ZONING BOARD OF ADJUSTMENT, PANEL B  
WEDNESDAY, APRIL 20, 2016  
AGENDA

<b>BDA156-028(SL)</b>	1212 Tavaros Avenue <b>REQUEST:</b> Application of Jerry Dieker, represented by Steve Gibson, for special exceptions to the landscape and alley access restriction regulations, and a variance to the off-street parking screening regulations	1
<b>BDA156-030(SL)</b>	5401 Miller Avenue <b>REQUEST:</b> Application of Christian Patterson, represented by Tim Clyde, for special exceptions to the visual obstruction regulations	2
<b>BDA156-036(SL)</b>	4407 W. Lovers Lane <b>REQUEST:</b> Application of Santos T. Martinez for a special exception to the landscape regulations	3
<b>BDA156-038(SL)</b>	4246 W. Lovers Lane <b>REQUEST:</b> Application of Andrea Winters, represented by Marc Jennings, for a special exception to the off-street parking regulations	4

**FILE NUMBER:** BDA156-028(SL)

**SITE PLAN**  
ADMINISTRATION OFFICE  
TEXAS TEL COM CREDIT UNION  
1212 TAVAROS AVENUE  
DALLAS, TEXAS 75218

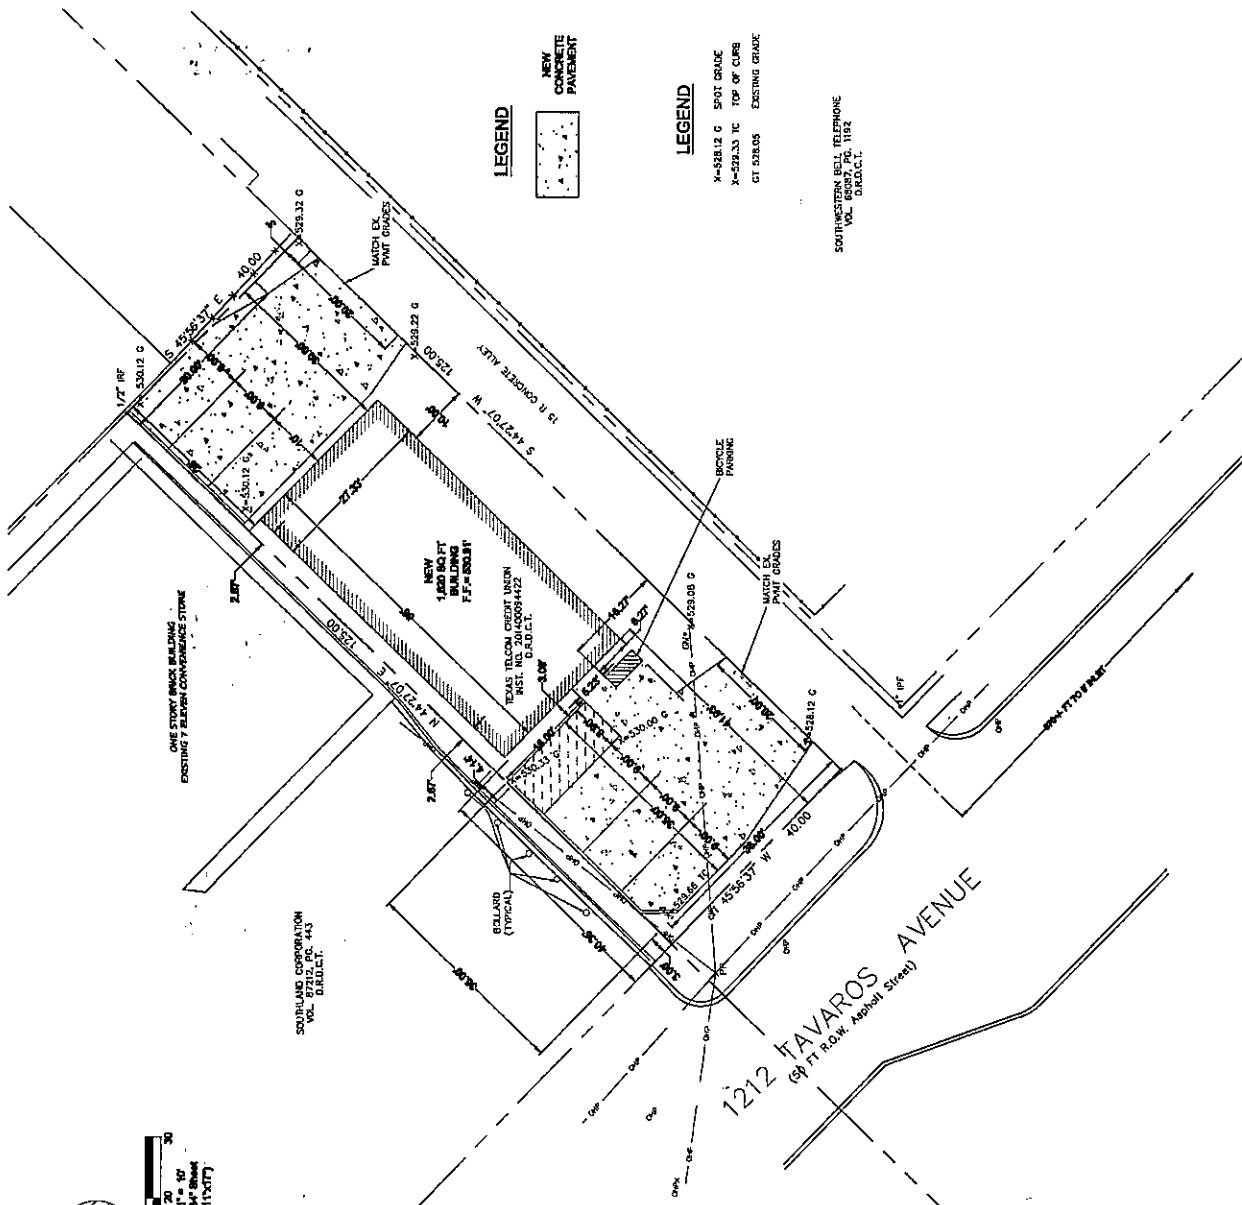
- The applicant has submitted a site plan that indicates no screening to be provided between the off-street parking on the site and the property to the south across an alley zoned R-7.5(A) and used as a surface parking lot.

- Compliance with the submitted site plan is required.

<b>LANDSCAPE PLAN</b> ADMINISTRATION OFFICE TEXAS TELCOM CREDIT UNION 1212 TAVAROS AVENUE DALLAS, TEXAS 75218			
DESIGNER JWE		DATE 01/08/18	
CHECKED BY JWE		ASSOCIATES JEZELL & ASSOCIATES 2211 TEXAS DRIVE IRVING, TEXAS 75062 972-788-0781 P.E.M. REG. NO. 5-4776	
SHEET <b>C-7</b>			TOTAL SHEETS 10

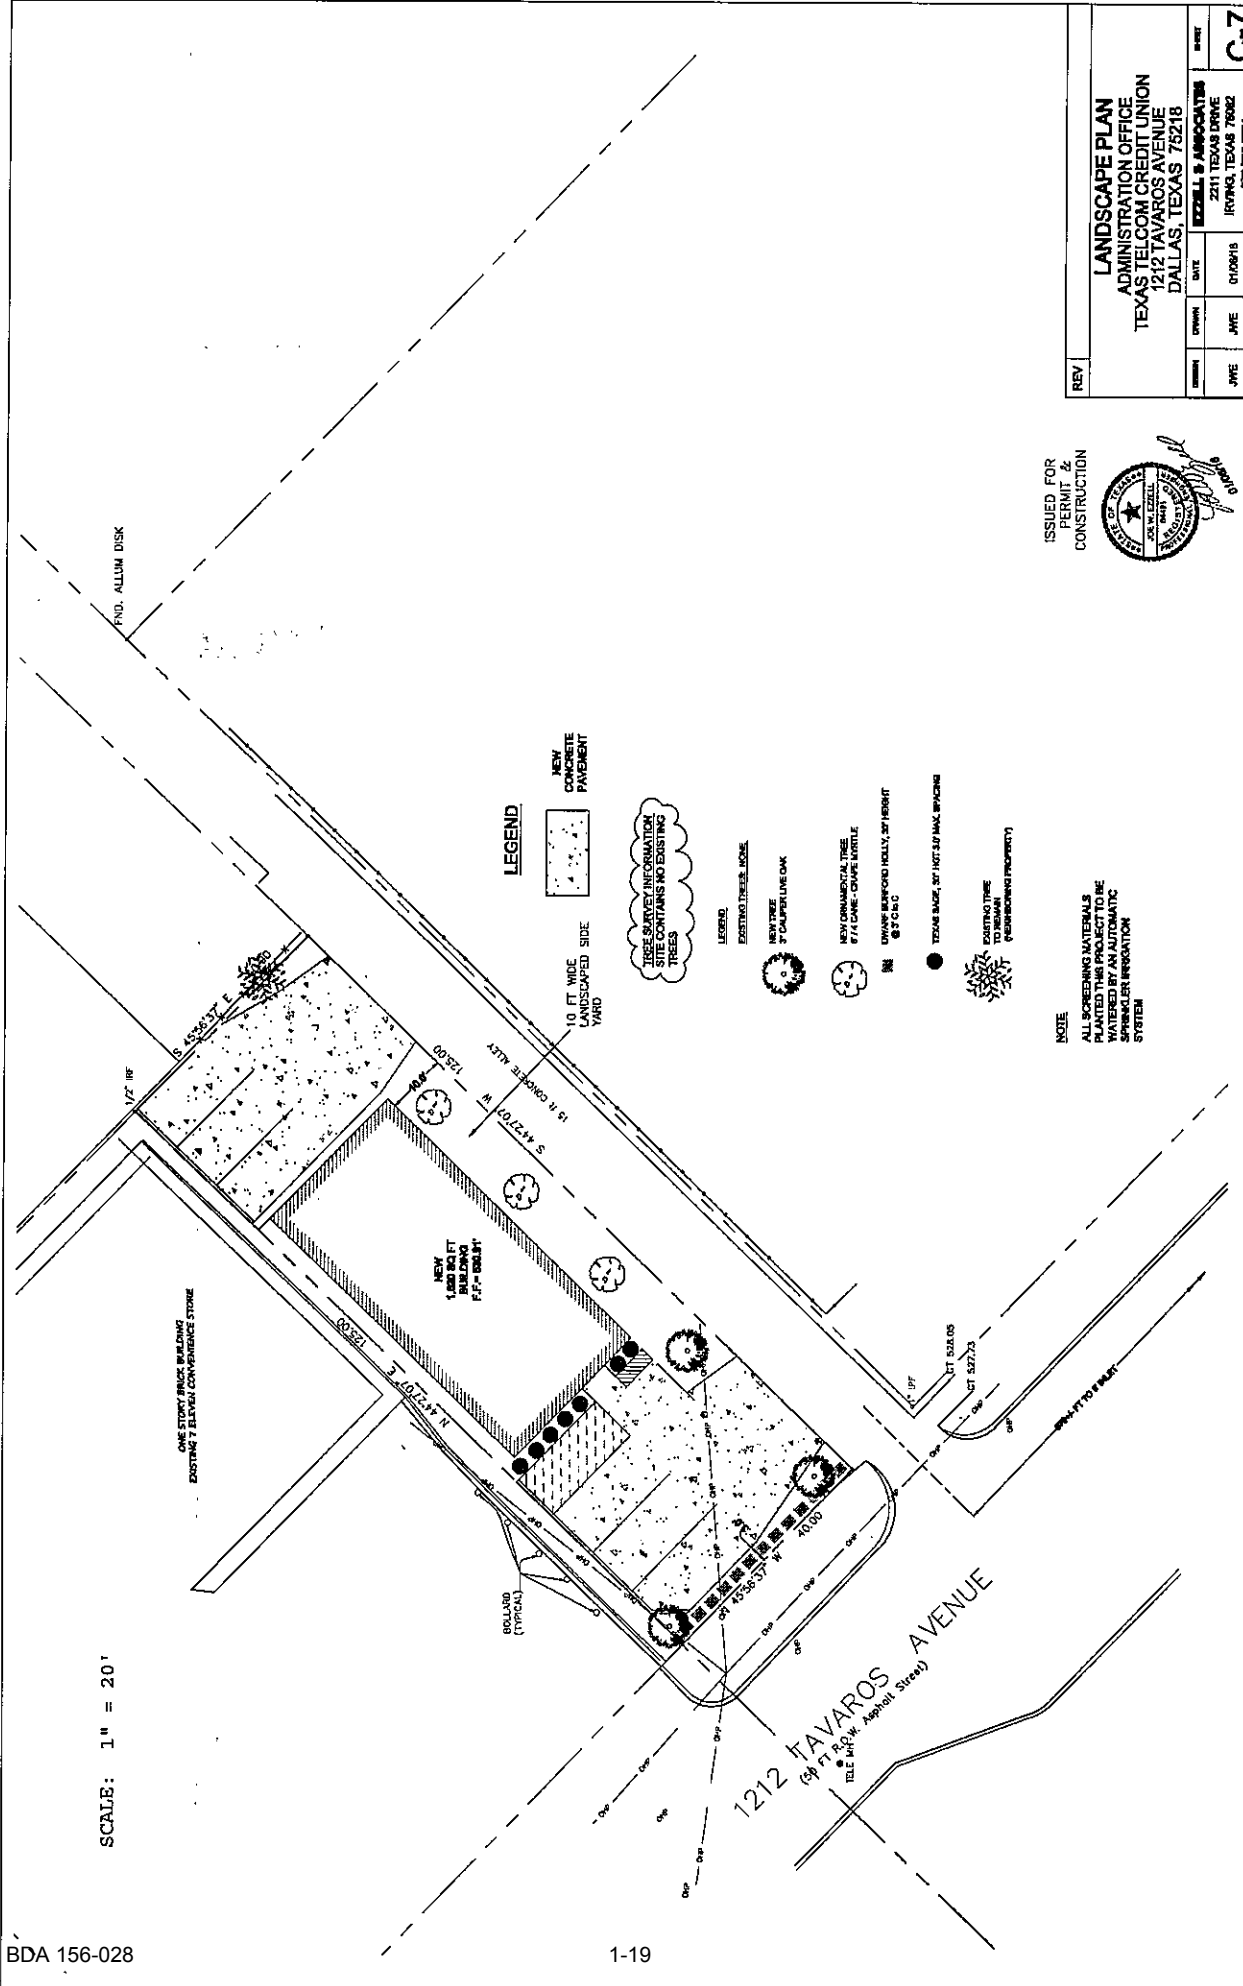
Under current conditions, where vehicular alley access to the property is prohibited, the pavement within the buffer area exceeds the maximum amount of nonpermeable coverage allowed for a perimeter landscape buffer strip where residential adjacency exists (10.125(b)(1)). One large tree is required for each 50 feet of perimeter landscape buffer. One tree is provided where three are required, and the mandatory buffer plant materials are not provided (10.125(b)(7)).

The plan identifies a large tree at the rear of the property is on the adjacent lot and abutting an existing structure. A minimal area of permeable area is to be retained around the tree on this building site. The area must be kept permeable for the duration of the life of the tree.

Two new street trees are provided along Tavaros Avenue. The area is restrictive in space, but appear to have the minimum soil area requirements for the trees. The trees must meet the minimum planting requirements of Article X and be planted not closer than two and one-half feet to the pavement.

The chief arborist recommends denial of the proposed alternative landscape plan because I do not believe that strict compliance with the requirements of this article will unreasonably burden the use of the property. If authority is given to provide the ingress and egress to the property through the alley, it is demonstrated by this plan the property does have sufficient landscape area, with adjacent parkway space, to meet the minimum planting conditions for the required landscaping.

In making proper species selection and wise use of the very limited landscape area, I believe the site can accommodate two street trees, four site trees, screening of off-street parking (either by shrub or screening fence), and the foundation planting. The 10-foot wide perimeter buffer strip can provide for a combination of large trees and large shrubs, and/or small trees, to meet compliance with the required buffer plant materials.

If the Board chooses to support the plan, I recommend compliance with the alternative landscape plan is required with condition of full compliance with the General Division (10.100) of Article X.

LANDSCAPE PLAN

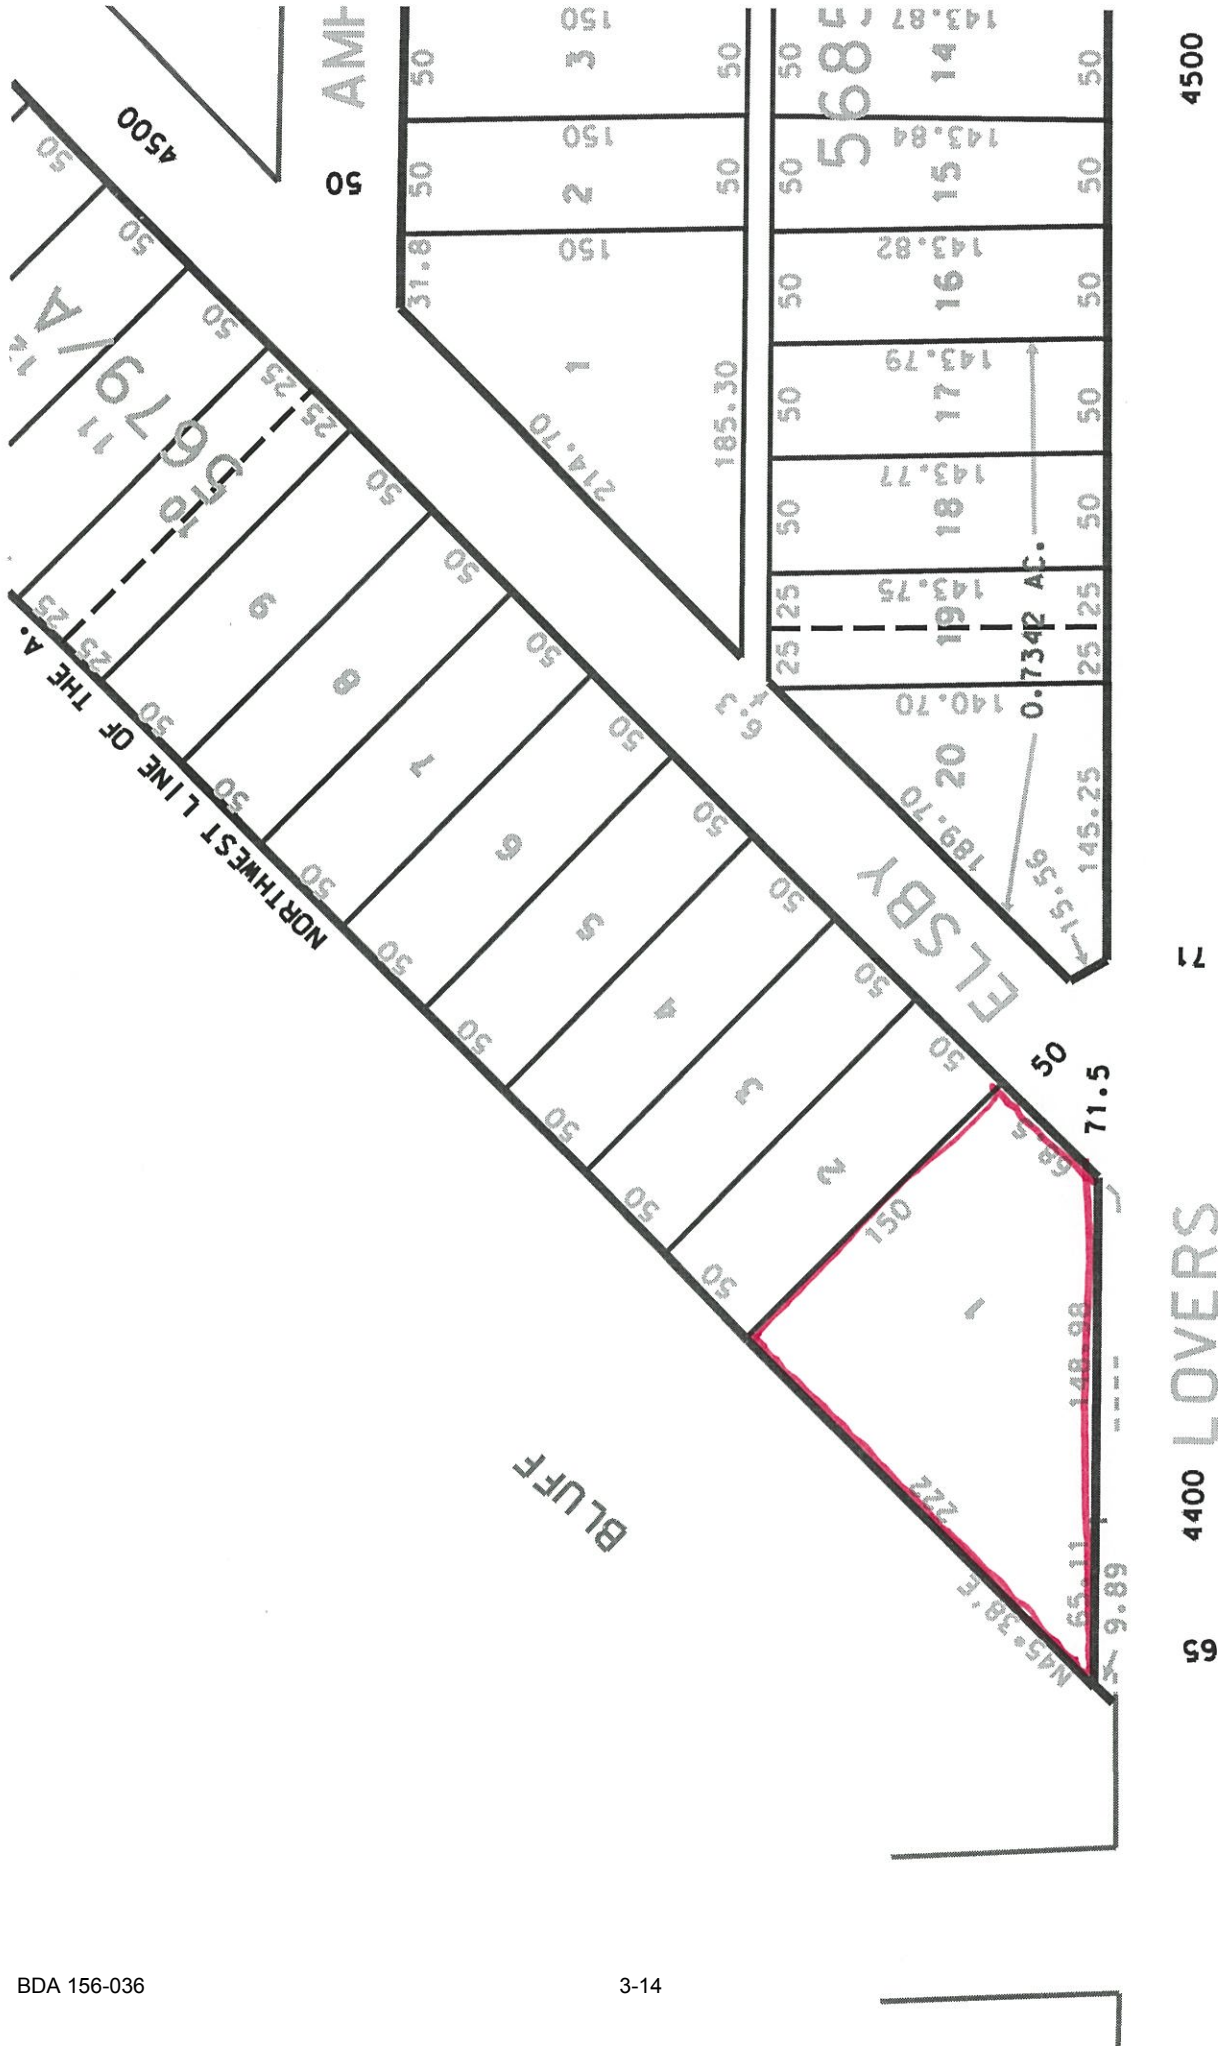
The revised proposed plan provides for a reduced 5-foot wide perimeter landscape buffer strip for the side yard from Taos Road, and also a 5-foot wide strip for the side yard from Elsby Avenue. There is no perimeter landscape buffer strip in the rear yard adjacent to the R-10(A) zoning district.

A review of engineering plans for this project identifies a 'proposed 10' storm sewer easement' in proximity to the required perimeter landscape buffer strip.

The entire adjacency frontage is approximately 460 feet in length which would require a minimum of 9 buffer plant groups (9 large canopy trees) for Article X compliance. The revised proposed plan shows three new live oaks. Six Texas redbuds, classified by the Texas Extension office as a small tree (growing 15-20' in height), would not be listed as a large tree for compliance. An interior live oak tree was shown in the pedestrian area to help relieve the lack of buffer plant materials on the perimeter.

All large trees are now scheduled for removal under the revised alternate landscape plan, except for a cluster of pecan trees on the western perimeter.

Provided dimension control plans also indicate a 4" to 16" tall retaining wall along Lover's Lane which is not identified on the revised alternative landscape plan.

The chief arborist recommends denial of the revised alternate landscape plan. A proposed 4"-16" tall retaining wall was identified on the same dimension control plans for the project which also located the placement of the storm sewer easement in the rear yard. The wall would be centered within the already restricted Lover's Lane landscape area and would negatively impact available tree planting and screening plant areas. The combined impact of the reduced perimeter buffer strip and reduced ability to sustain large trees in the street planting strip is not supportable by staff.

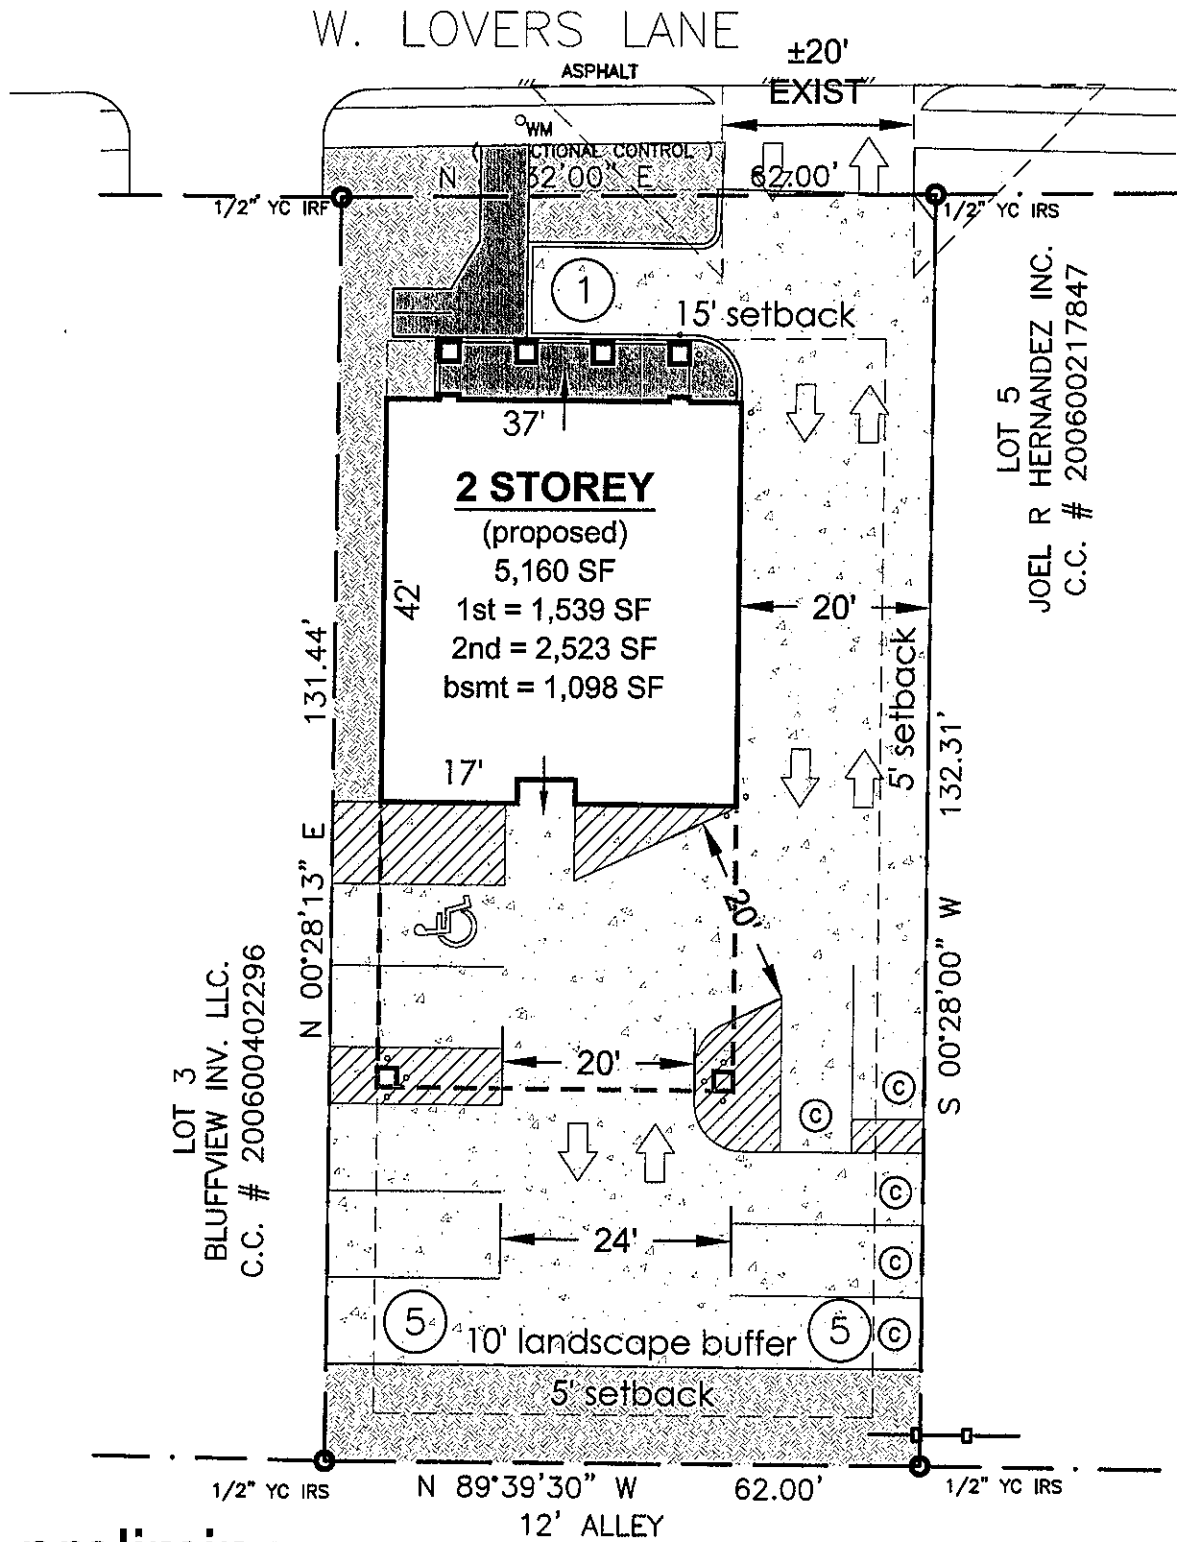
- The Sustainable Development Department Project Engineer submitted a review comment sheet marked “Recommends that this be denied” commenting: “Lovers Lane is classified as a Minor Arterial with no apparent on-street parking available. Overflow parking would most likely result to parking along Arco Avenue and South Crest Haven Road potentially increasing traffic congestion.”
